SUBJECT: Forwards Revision 2 to "Diablo Canyon Project QA Program,"
 in response to DG Eisenhut 821202 request.

Re: Docket No. 50-275, OL-DPR-76
Docket No. 50-323
Diablo Canyon Units 1 and 2
Diablo Canyon Project Quality Assurance Program

QUALITY ASSURANCE PROGRAM

DIABLO CANYON PROJECT

Diablo Canyon Project Team Organization Attachment 5

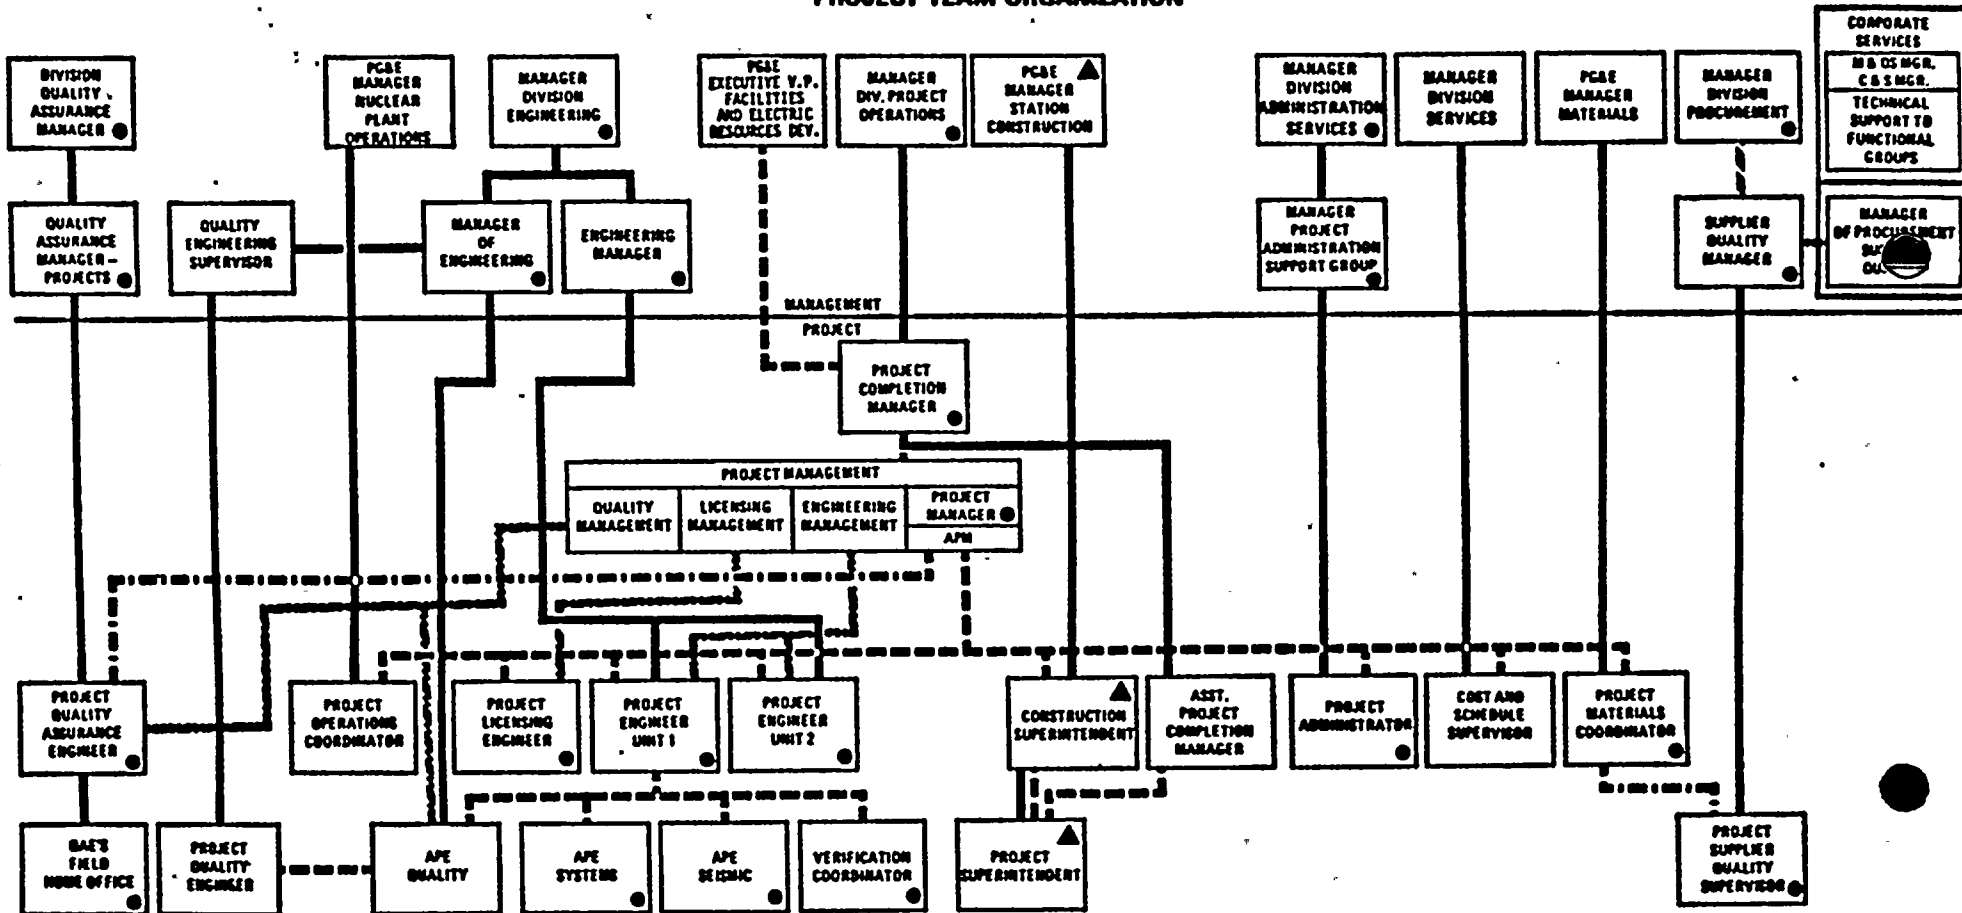
Q.2 | Replace
Fig. 9
with
Attachment 5
